Memo

Re: Instructions for Wednesday, July 29, 2020 Planning Commission Meeting

Background Information & Staff Recommendations
City of Springboro Planning Commission Meeting—Conducted by Conference Call (Zoom)
Wednesday, July 29, 2020, 6:00 p.m.

Advance Drive PUD, Planned Unit Development, new commercial building

* The light loss factor (LLF) is a product of many variables, only lamp lumen depreciation (LLD) has been applied to the calculated results unless otherwise noted. The LLD is the result (quotient) of mean lumens / initial lumens per lamp manufacturers' specifications.

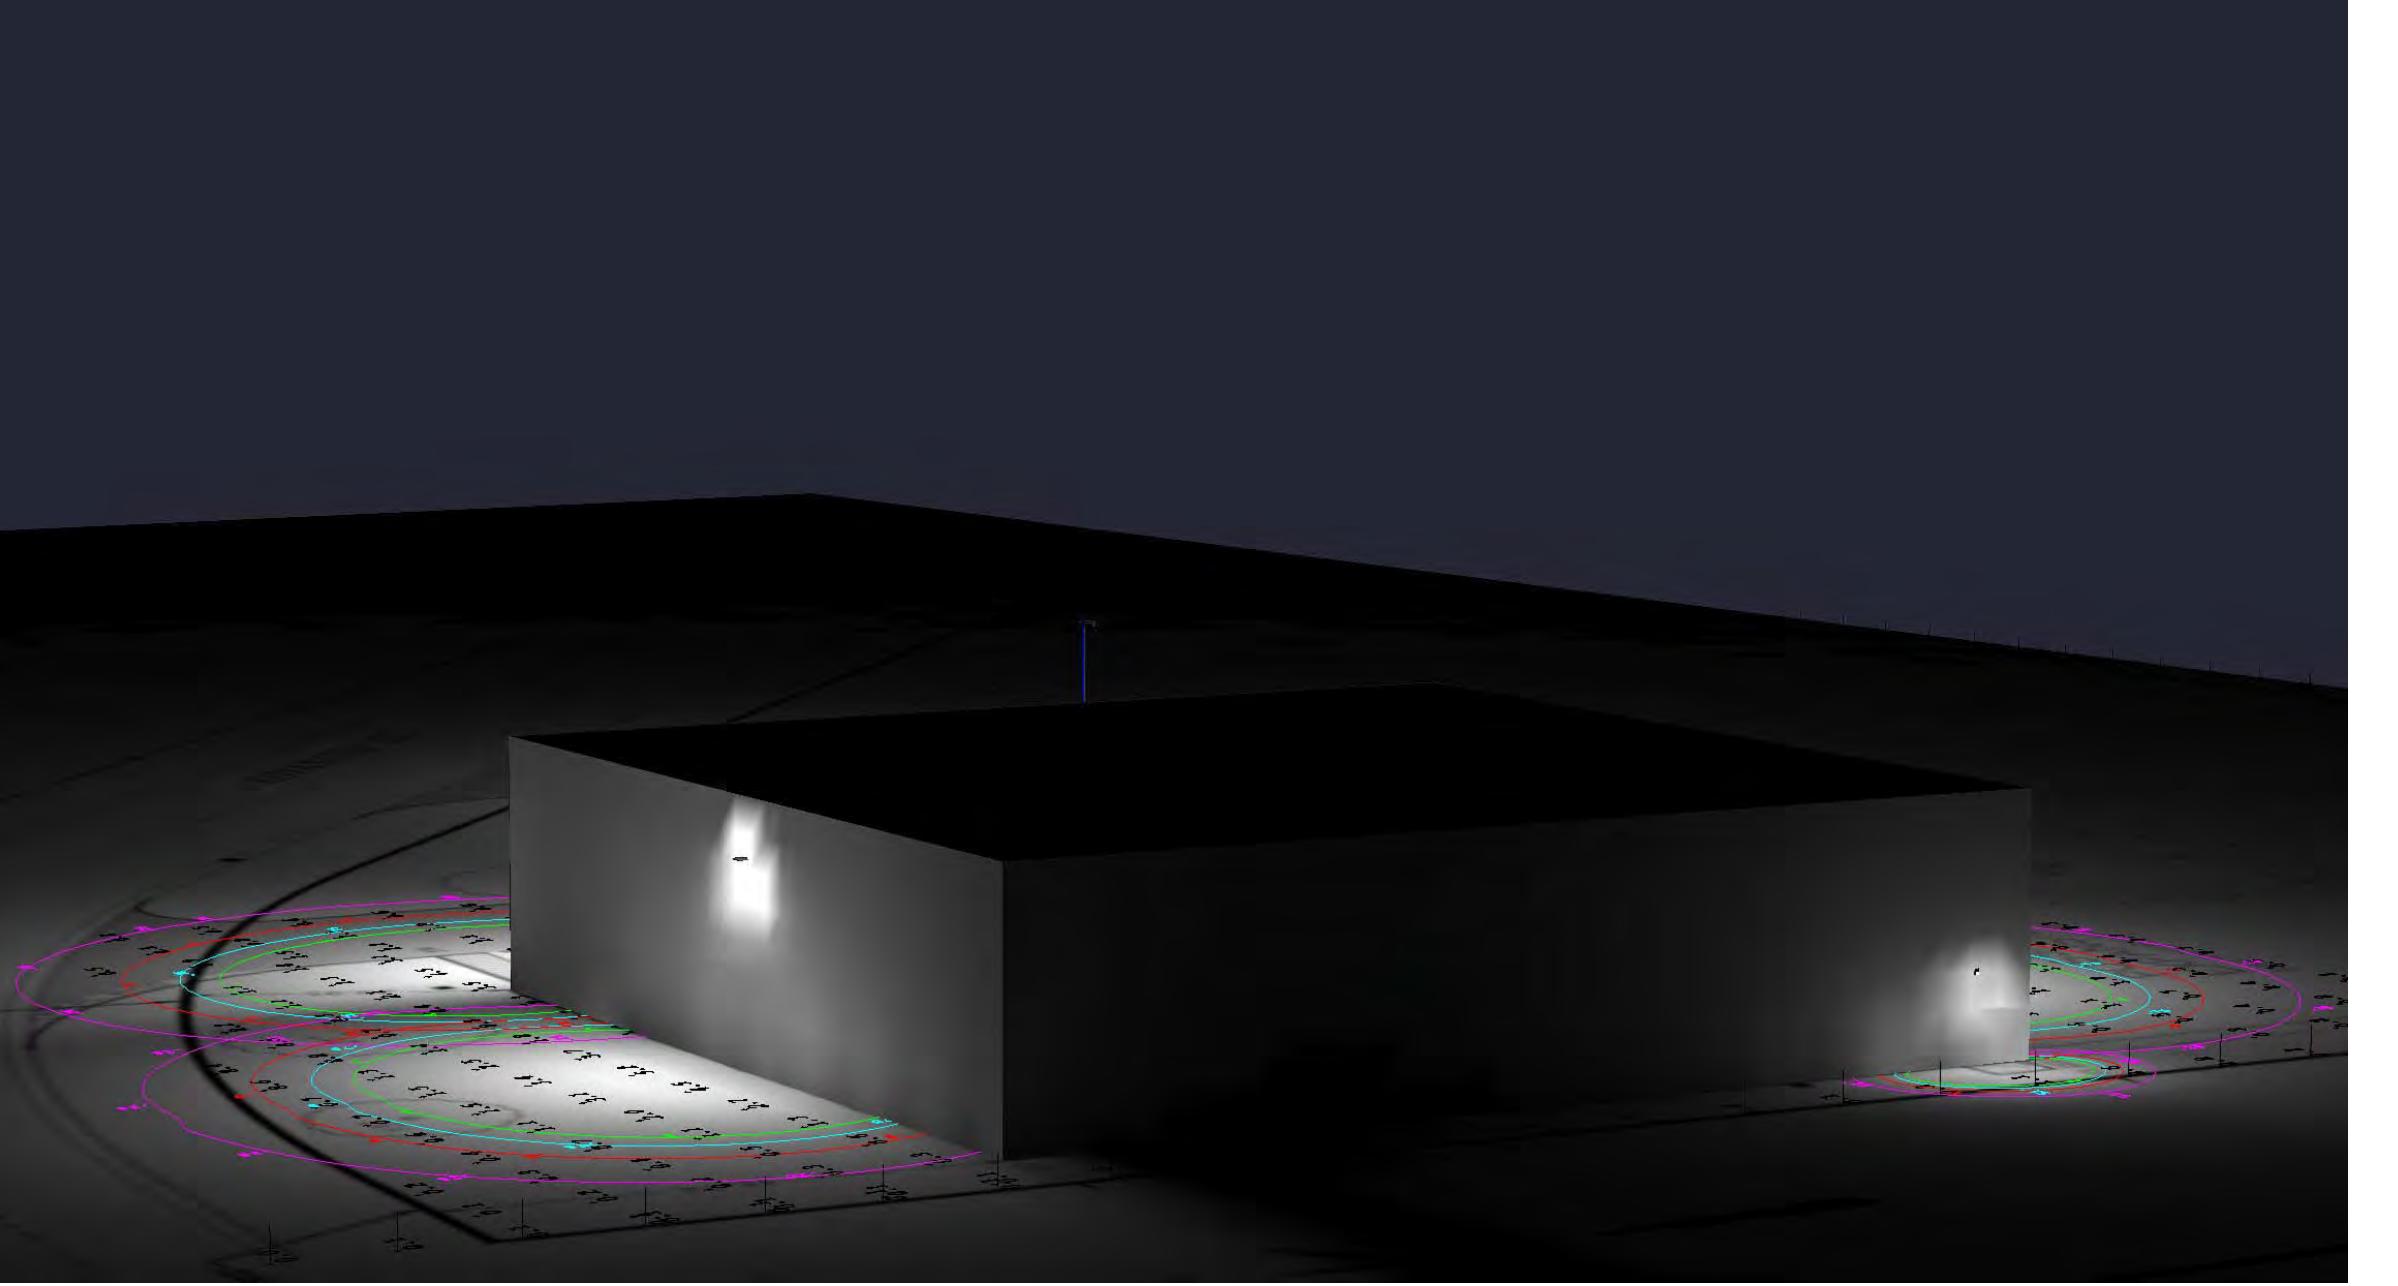
1. Regarding the proposed lighting plan, staff has the following comments:

- a. Proposed wall pack lighting is not acceptable. Coordinate with City staff on an acceptable fixture.
- b. Verify if lighting fixtures proposed comply with maximum 3500° Kelvin color-temperature standard.
